16TH STREET BRIDGE AT THE ARIZONA CANAL DIVERSION CHANNEL
AND
SANITARY SEWER LIFT STATION

FCD CONTRACT NO. 89-46

CONSTRUCTION SPECIAL PROVISIONS

A PORTION OF SHEET 5 of 23

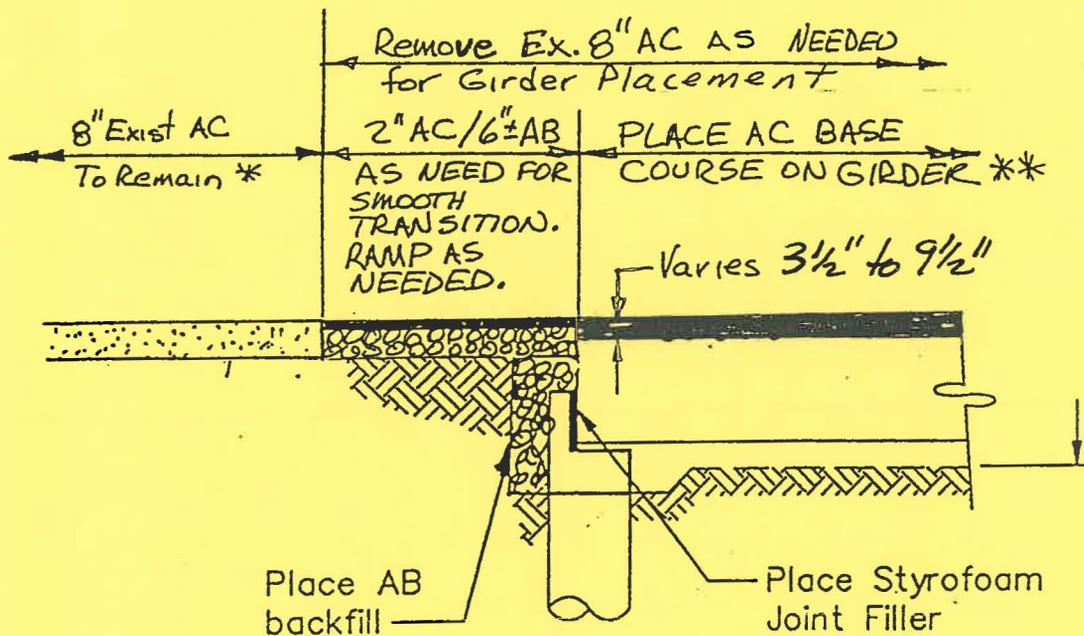
Revise "TRANSITION DETAIL" for Phase 4 - Weekend Traffic Closure (A) as shown on a portion of Sheet 5 of 23, see attached revised TRANSITION DETAIL.

* Maintain as much existing AC as possible until underpass is installed. After underpass is complete replace AC to AZ Canal bridge with 8", MAG C-3/4, asphalt pavement. 2" AC over 6" AB transition pavement shall be installed and maintained in the approach slab areas until the concrete approach slabs are installed.

** Place 1-1/2" to 7-1/2", AC MAG C-3/4, on girders after installation. Place final 2" AC, MAG C-3/4, overlay on approach slabs after the concrete approach slabs are installed.

A PORTION OF SHEET 8 of 23

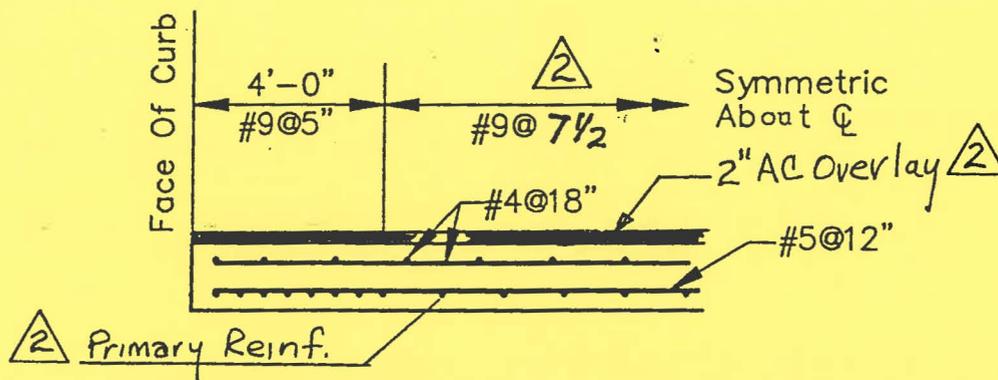
Revise "Primary Reinf. #9 bars at 8" or 5" O.C." as shown on APPROACH SLAB DETAILS, sheet 8 of 23 TO "Primary Reinf. #9 bars at 7 1/2" or 5" O.C.". See attached revised detail, a portion of sheet 8 of 23.

Approach Slab Detail per ADOT Standard
No. B-19.11 (Modified) See Det Above

Plan Sheet No. 17

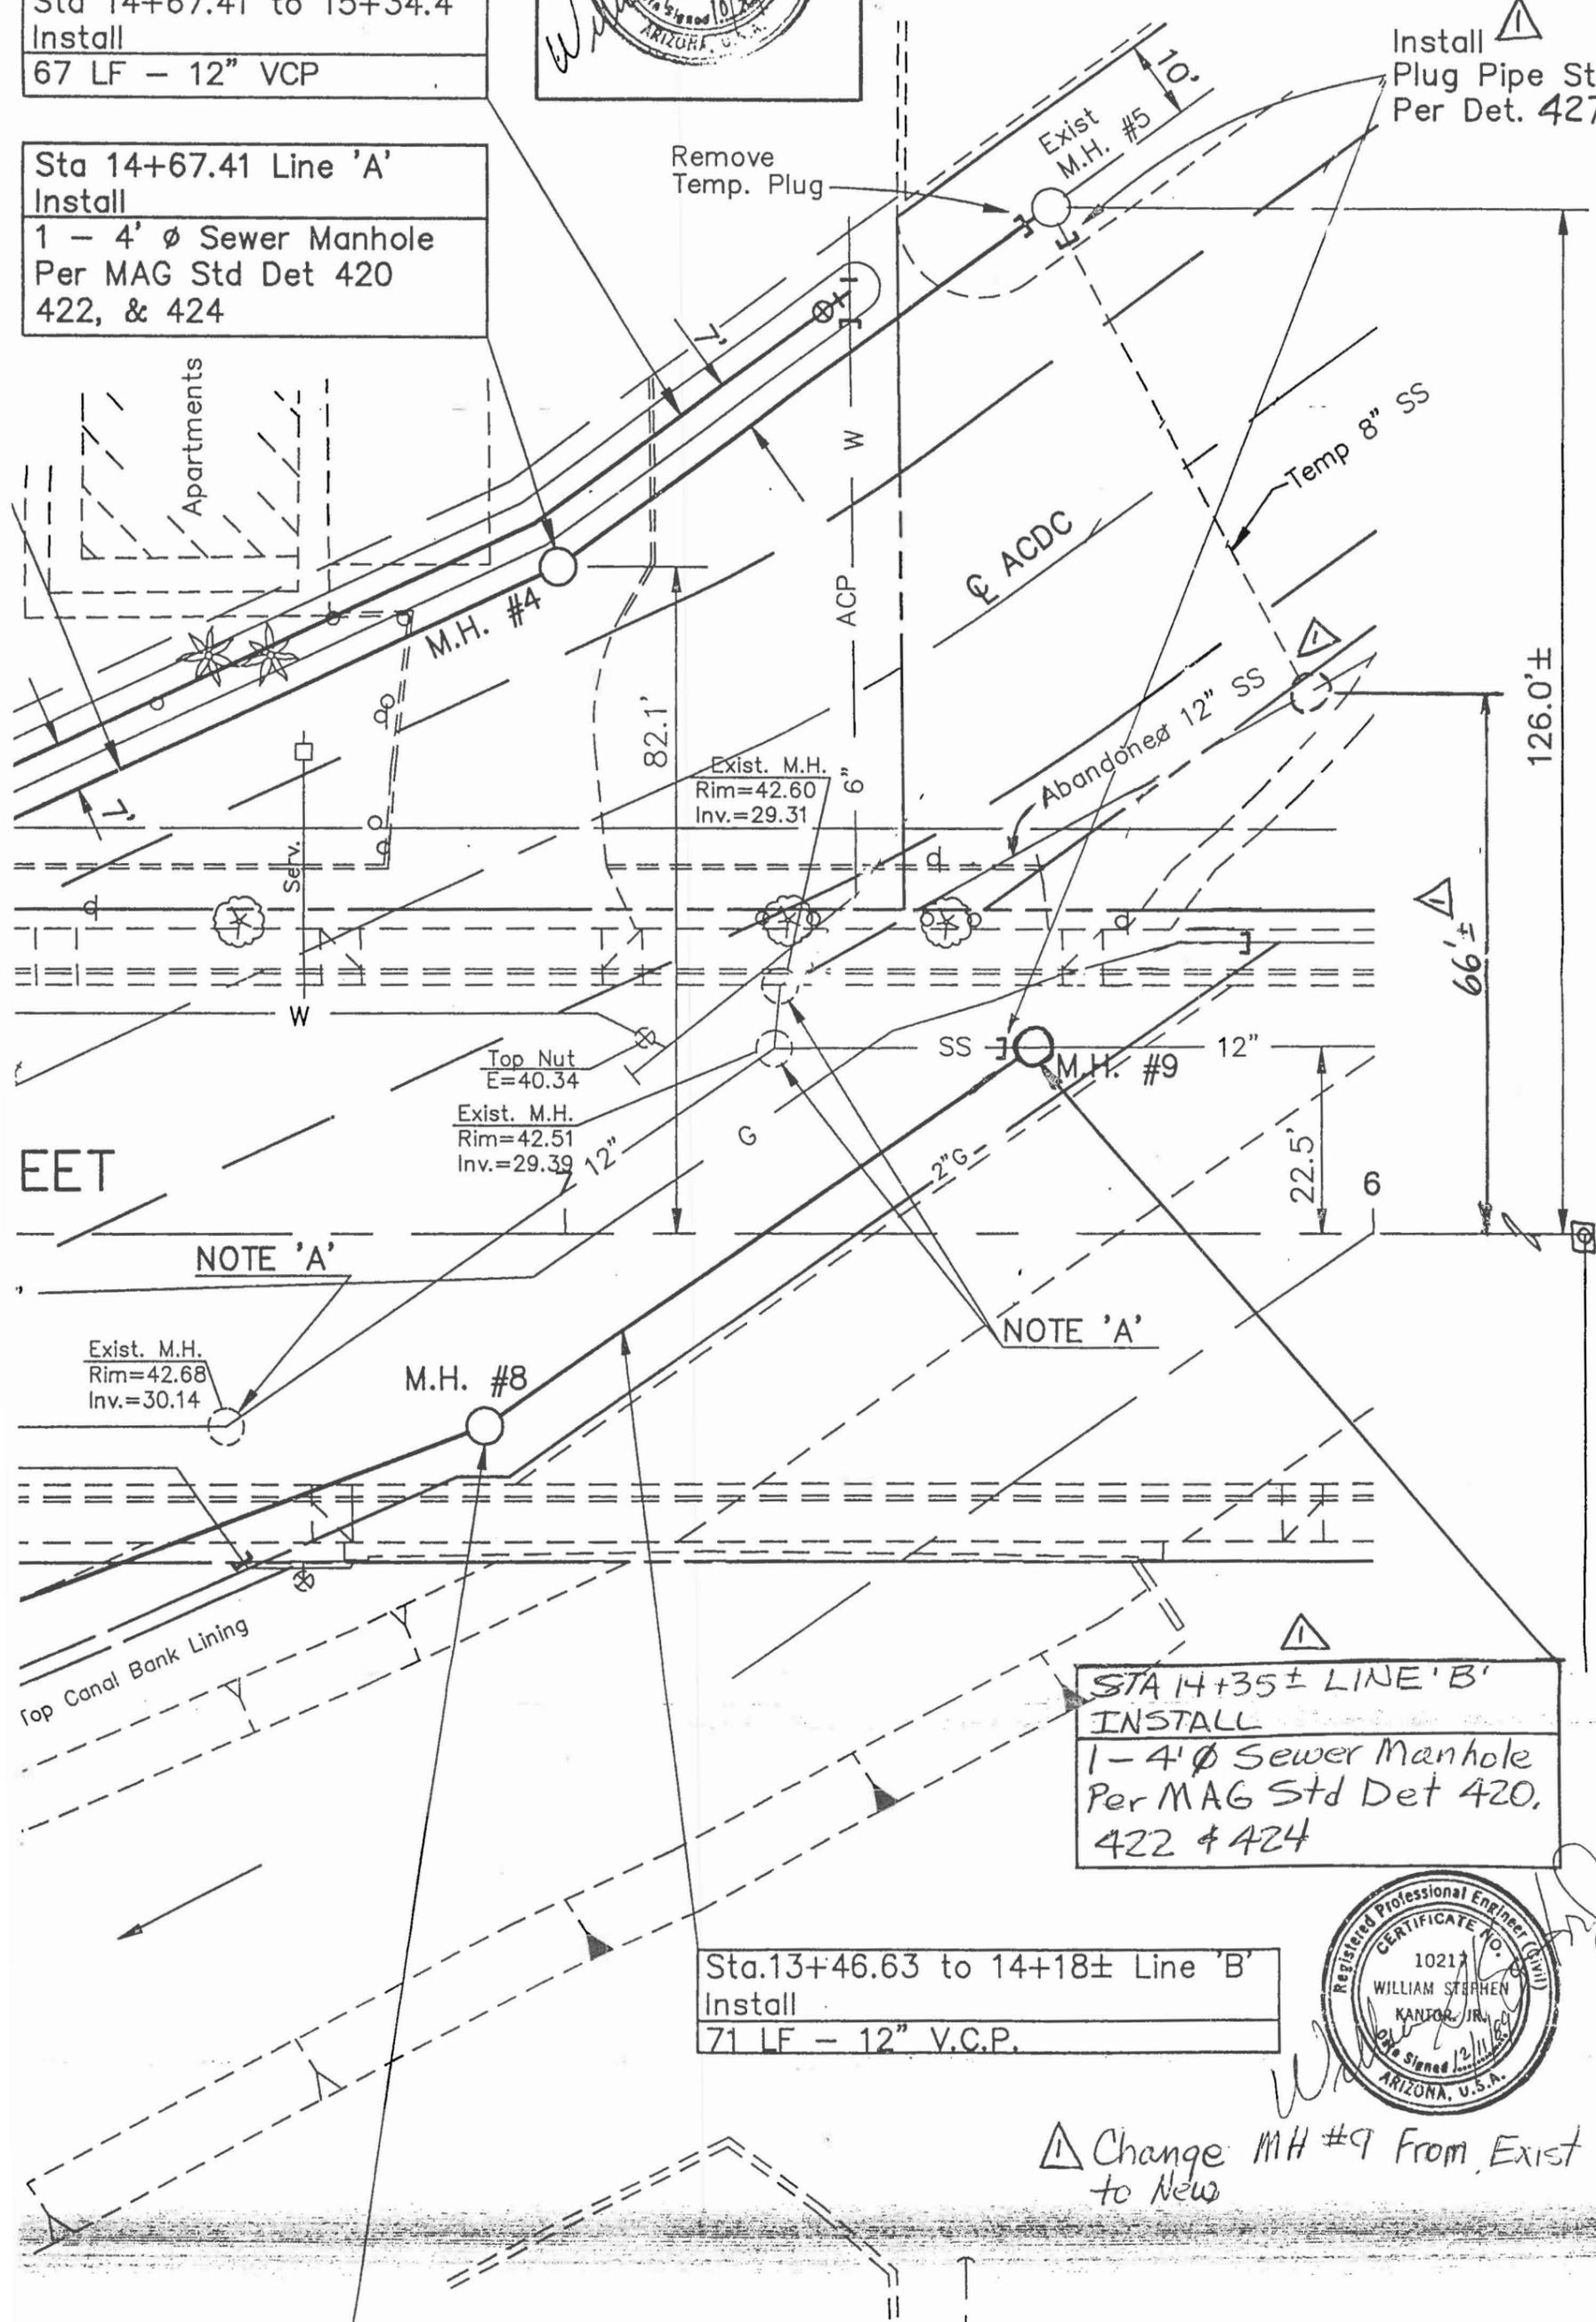
- C. Construction Plans:
Revise a portion of Sheet 17 showing that Manhole #9 is new instead of existing.

Revise a portion of plan sheet 17 of 23 showing existing manhole number 9 as a new manhole to be installed on this project. See the attached revised portion of sheet 17 of 23.

Change MH #9 From Exist
to New
